**Pisolite Hills Project**

**Wenlock Basin Wild Rivers Submission**

**Cape Alumina Limited**

May 2009

Figure 3: Impact of the proposed HPA on the Pisolite Hills project. Pink area shows the JORC Code-compliant bauxite resource.

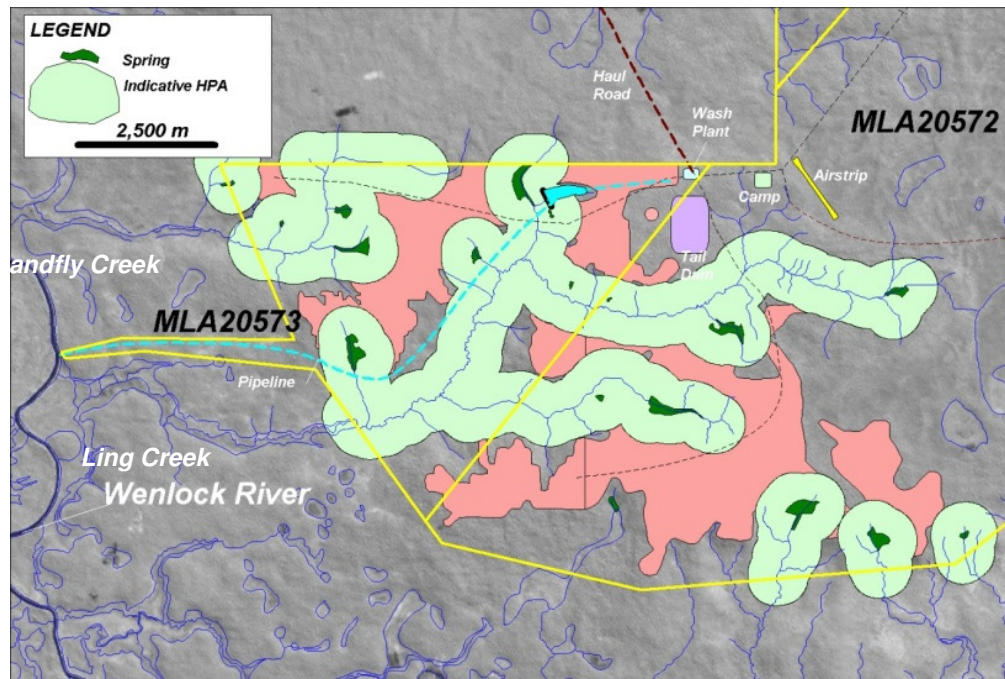
It is understood from the *Department of Natural Resources and Water (DNRW) guideline Wild Rivers Guide – Mining and Exploration* that surface mining activities are not permitted in a High Preservation Area. As indicated in Schedules 1 and 2 of the Wenlock Basin Wild River Declaration Proposal and in GIS layers provided by DNRW, the proposed High Preservation Areas of the Proposal will greatly restrict the activities proposed for the Pisolite Hills Project (Figure 3) and will have a significant detrimental impact on the project feasibility.

The effect of the Proposal as it currently stands will be to sterilise at least 15% of ML20572 and at least 58% of ML20573 which will result in the sterilisation of at least 28% of the JORC-code compliant Indicated Resource at Pisolite Hills. The estimated value of the bauxite which will be sterilised under the Proposal on the Cape Alumina Mining Leases alone is estimated to be approximately \$1 billion. Should the loss of this portion of the resource result in the project becoming unviable, the estimated lost revenue will approximate \$3-\$4 billion. In addition, hundreds of full time jobs will be lost.

Moreover, some environmental features in the vicinity of Pisolite Hills that we believe warrant protection are notably excluded by the proposed arbitrary buffers. For instance the evergreen spring shown in the lower middle section of Figure 3 to be outside the proposed arbitrary HPA, but covered by our recommended case by case HPA in Figure 7. We believe this highlights the inappropriateness of arbitrary HPA's, or buffer zones, in an area for which there is a large body of scientific data available.

Figure 6: Mapping errors in the definition of Special Features

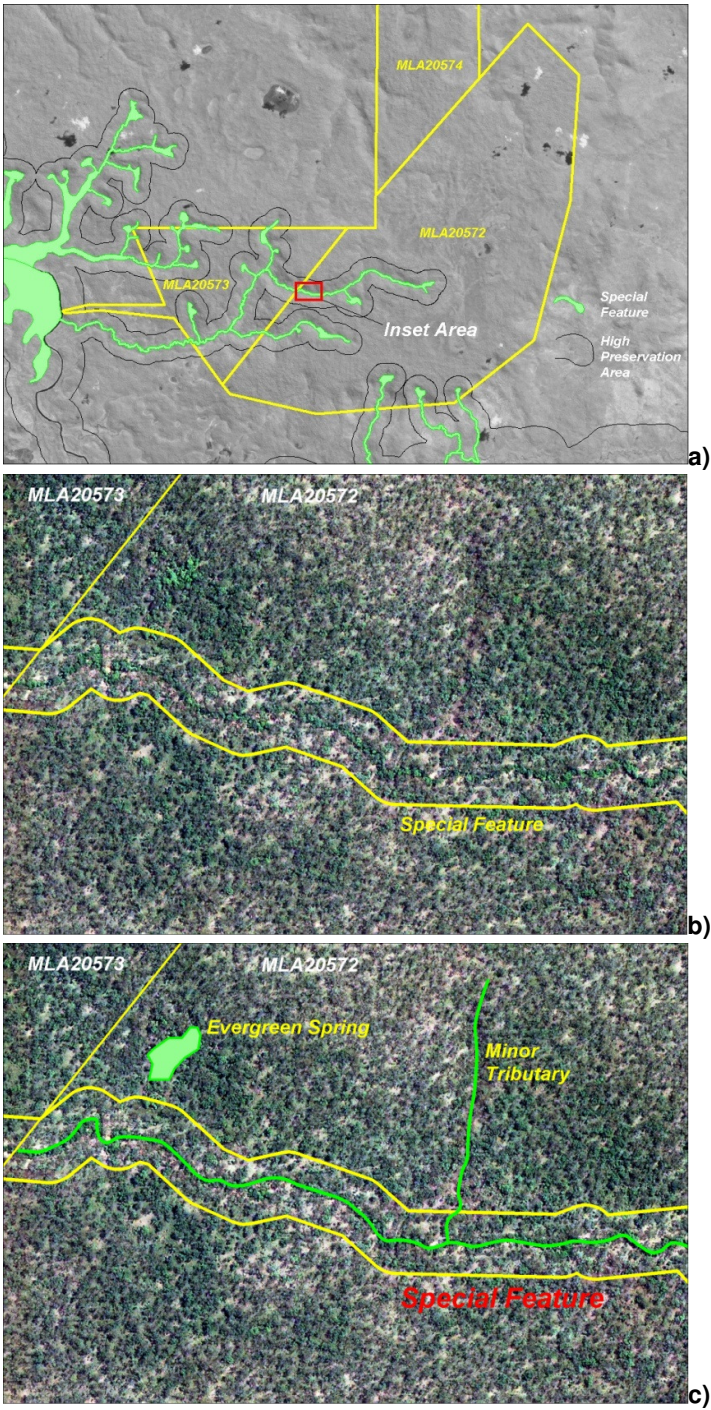
The High Preservation Area (HPA) setback zones associated with Ling Creek, Sandfly Creek, and the Special Features in the vicinity of Pisolite Hills are provided in the Declaration Proposal (as shown in Figure 1 and 3). Mapping of the GIS layers supplied by DNRW shows that buffers extending 500m either side of all Special Features are proposed to be designated as High Preservation Areas. However, no documentation supplied by DNRW contains an explanation or justification for the determination of the extent of these buffer zones, and there is no reference given to published literature or accepted practices for environmental buffers. It must therefore be concluded that the proposal is simply an arbitrary determination, with lines drawn on a map without the benefit or consideration of actual site-specific scientific data on the ecology or hydrology of the site.

Furthermore, it can be shown from the GIS data derived from the Overview Report, that the Special Features in the vicinity of Pisolite Hills are in fact buffers around the environmental features rather than the mapped outlines of the environmental features themselves. Figure 6 illustrates the errors in mapping of the Special Features in the vicinity of Pisolite Hills (Figure 6a) as shown in the overview report. Figure 6b) is a close-up of the Special Feature which is a tributary of Ling Creek. The yellow lines are 100m apart and represent a 50m buffer either side of the creek line. In Figure 6c) the actual riparian zone around the tributary is highlighted. This riparian zone has an average width of between 5 and 10 metres. In addition, the “Special Feature” as mapped in the Overview Report excludes both a tributary and an evergreen spring, but includes a wide zone of open dry Stringybark woodland unrelated to the tributary or its riparian zone.

Similarly, mapping of those springs defined as Special Features includes buffers extending up to 85m out from the wet edge of the springs. It is from the edge of these buffers that the HPA starts (Figure 6a).

The result of these proposed buffers upon buffers means that the actual HPA as proposed at Pisolite Hills are a minimum of 1120m wide. This means that the declaration proposal as it currently stands is to establish HPA over buffers extending up to 112 times the size of the actual environmental feature being protected. This is far in excess of any recommended buffers based on any scientific publication and is against the recommendations of independent ecologists.

There is no logic in the application of a buffer on a buffer and this approach will result in the unnecessary sterilisation of JORC Code-compliant ore resources at Pisolite Hills and threaten the viability of the project without any basis in environmental science.

The tributaries in the vicinity of Pisolite Hills are very narrow and Cape Alumina recommends that mapping of the Special Features be restricted to the features themselves which, in the case of the tributaries, have a total width of between 5 and 15m in the immediate vicinity of Pisolite Hills. In the case of the springs, Cape Alumina recommends those feature be mapped to the wet edge.

**Figure 7:** Recommended HPA in the Pisolite Hills area based on a scientific appraisal of the environmental features.

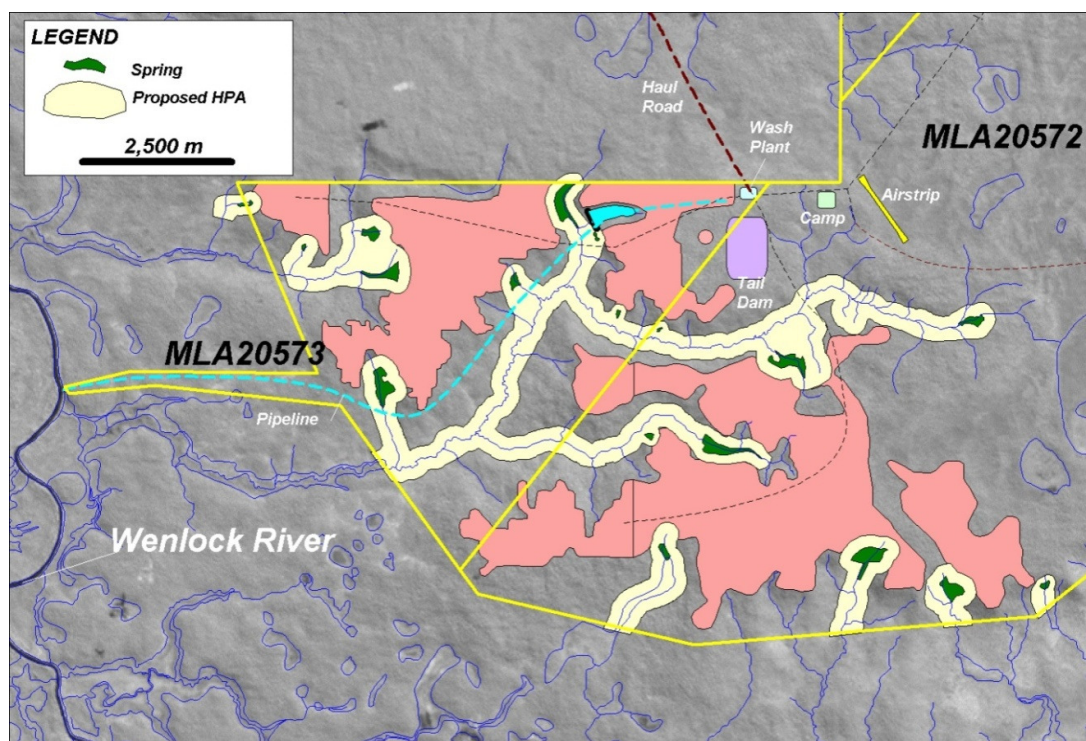
To address the functions outlined above, in keeping with the recommended buffer widths described in the published literature (Section 5.1) it is recommended that the following buffer widths are applied in the Coolibah Springs Complex:

- Small evergreen springs – 100m
- Medium evergreen springs – 150m
- Large evergreen springs – 200m

These recommended buffers meet, and in most cases exceed, the maximum recommended buffer widths in recent published literature.

HPAs following this recommendation in the vicinity of Pisolite Hills (including on the adjacent Alcan Mining Lease ML7031) will ensure that both the springs themselves, their resulting watercourses and the surrounding vegetation are fully protected as High Preservation Areas whilst allowing for reasonable and carefully managed development of valuable and strategic mineral resources in the so called "Preservation Area".

The proposed boundaries are illustrated in Figure 7.

**Figure 10:** Pisolite Hills area - evergreen springs, tributaries and HPA based on a) scientific assessment as proposed by Cape Alumina, and b) arbitrary HPA as proposed in the Overview Report.

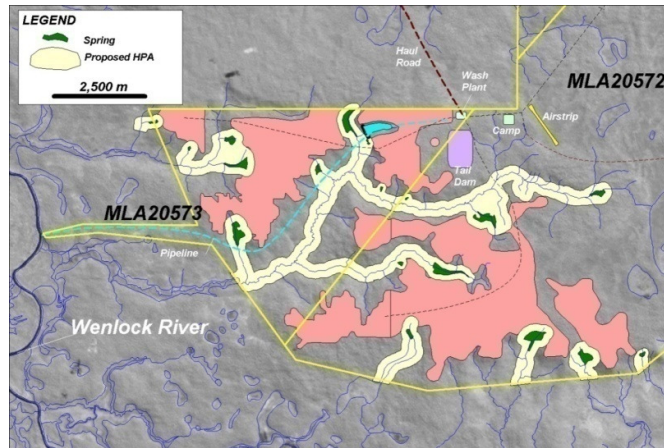
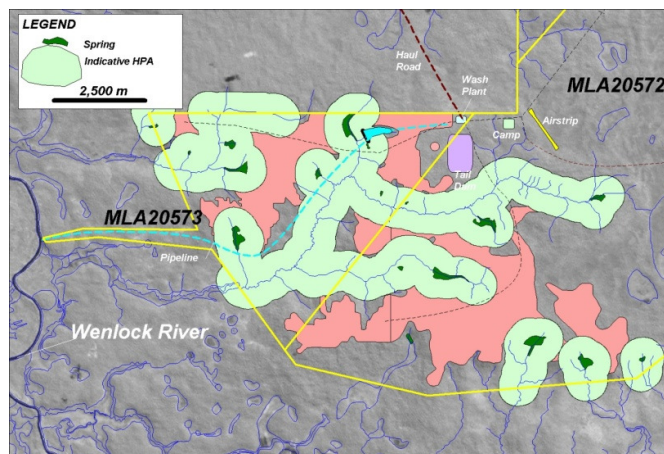
Figure 10 shows the distribution of ore resources and the actual mapped extents of the “Special Features” at Pisolite Hills. In Figure 10a) HPA as recommended in this submission and based on a rigorous scientific analysis are shown, whereas Figure 10b) illustrates the impact of the arbitrary HPA, as proposed in the Overview Report, on the mineral resources at Pisolite Hills.

Tables 4 and 5 list the impact of the two alternative HPA zones at Pisolite Hills on the current JORC code-compliant mineral resources. These tables show that the HPA as recommended by Cape Alumina in this submission will have a small impact on the mineral resource at Pisolite Hills by sterilising 2% of the total resource. In contrast, Table 5 shows that the HPA as proposed in the Overview Report will sterilise at least 28% of the mineral resources at Pisolite Hills.

It is not clear what impact such a significant sterilisation of resources will have on the Pisolite Hills project at this stage. It is easy to calculate the lost value of the sterilised resource at approximately \$1,000,000,000; however, it is likely that the project would not be viable with such a large loss of the resource base. This is due to the high capital cost of the project and the significant reduction in the life of mine that would result from the sterilisation. Furthermore, the arbitrary HPA will result in a disproportionately large sterilisation of the two highest quality ore deposits at Pisolite Hills being PH2 and PH4, where, respectively, at least 41% and at least 67% of the resources will be sterilised. It is concluded that there is a high probability that the project will not proceed should the Wenlock be
